1 MAY 1956

MODIFICATION OF HAMMARLUND COMMUNICATION RECEIVER
MODEL SP-600-JX-17 TO INCREASE OPERATIONAL EFFICIENCY

2. MODIFICATION DATA. (Globecom ECP #520-24)

Figure 1. Location of IF Gain Label and Card Holder

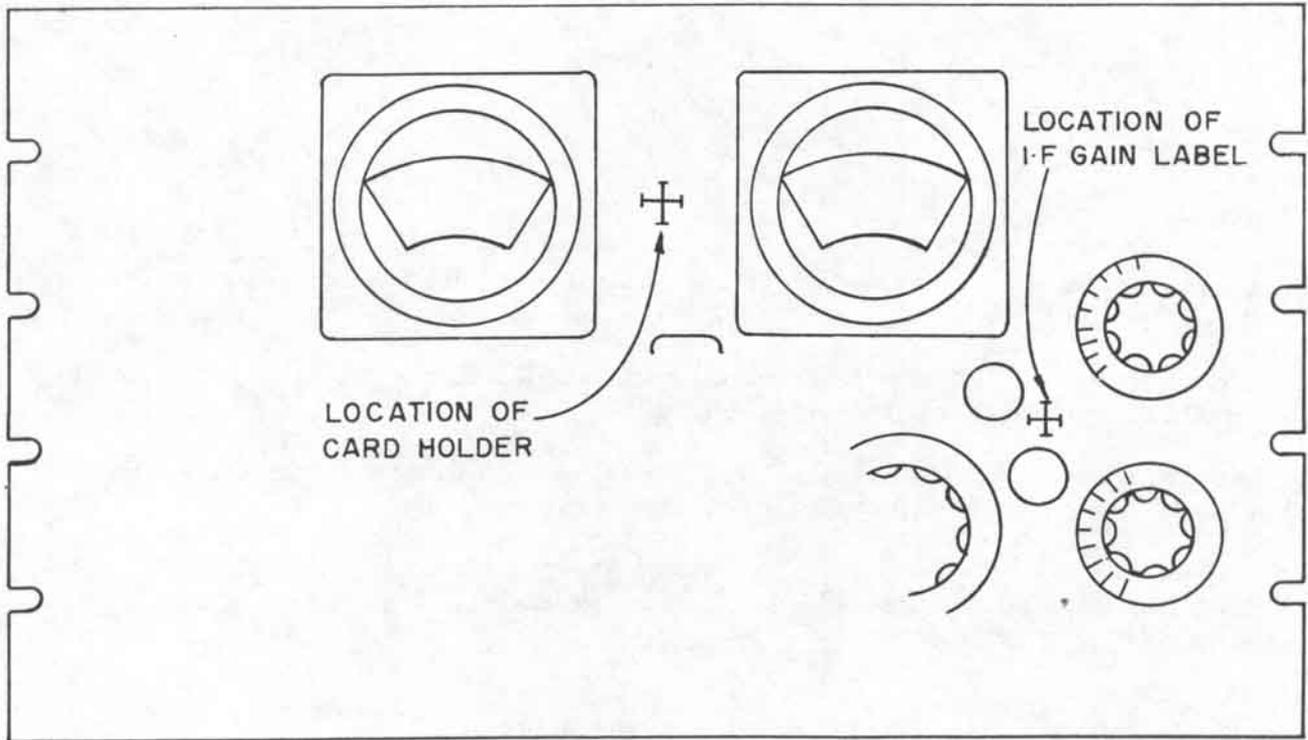
b. Addition of IF Gain label and card-holder to the front panel (see Figure 1).

- (3) Place the receiver on its back with the front panel up, in horizontal position.
- (4) Clean the panel surfaces between dial escutcheons and around lettering of dial tuning lock, using an approved cleaning solvent such as trichloroethylene.
- (5) Apply a coating of toluol, supplied in capsule form in the kit, to rear surfaces of IF Gain label and card holder.
- (6) Wait about 30 seconds or until surfaces are tacky, then place the IF Gain label centered over the dial tuning lock lettering, and the card holder centered between the dial escutcheons. Apply even pressure to both labels and allow the adhesive material to harden.

Figure 2. Installation of IF Gain Control

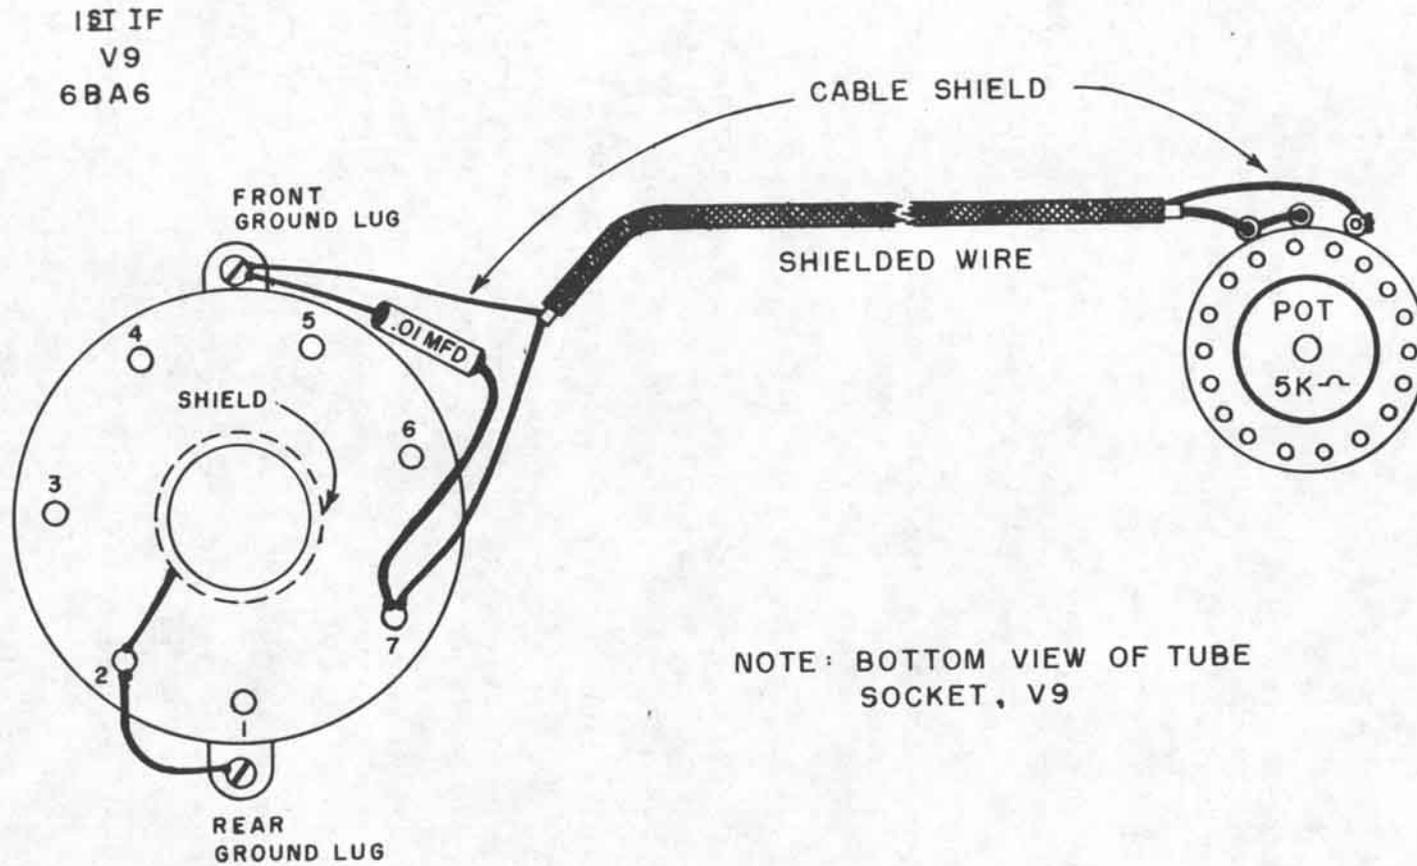
- (10) Connect pin 2 and center shield of socket for tube V9 to the rear ground lug of this socket (see Figure 2).
- (11) Connect the center conductor of new cable together with one lead of new 0.01 mfd capacitor to pin 7 of socket for tube V9 (see Figure 2).

- (12) Connect other lead of the new capacitor and cable shield to the front ground lug of the socket for tube V9 (see Figure 2).

Figure 3. Schematic Diagram of Modification to IF Stage

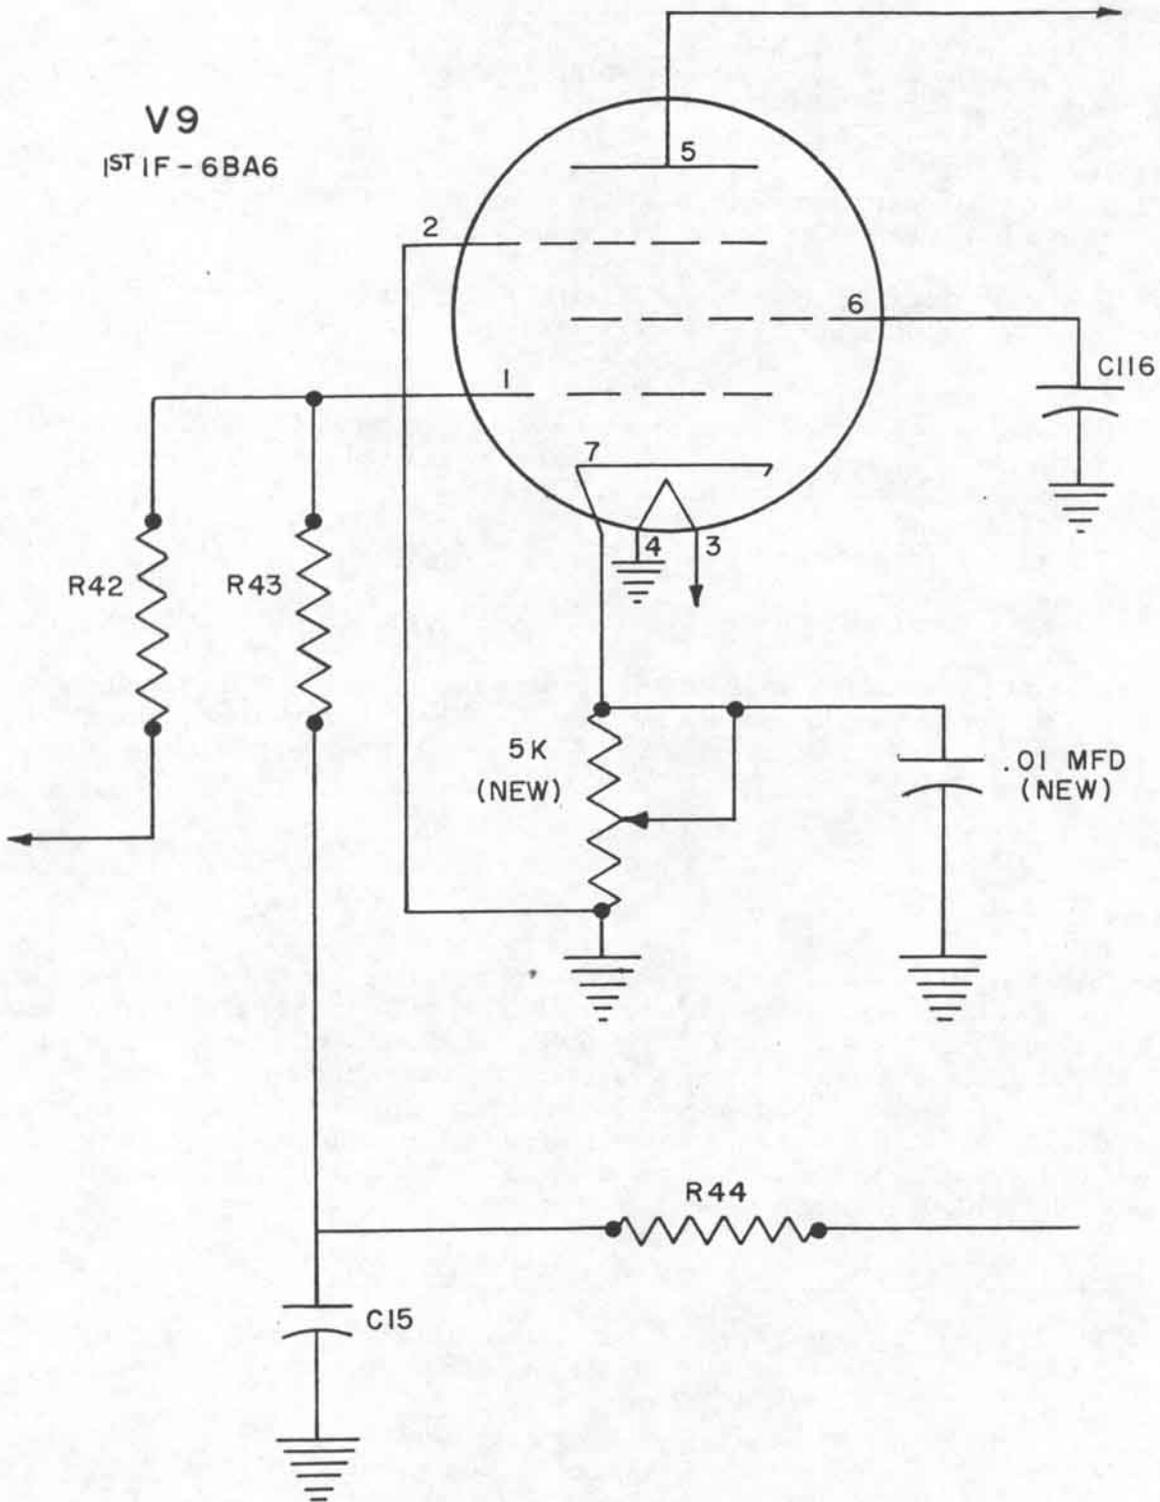
(14) Check the modification against Figure 3.
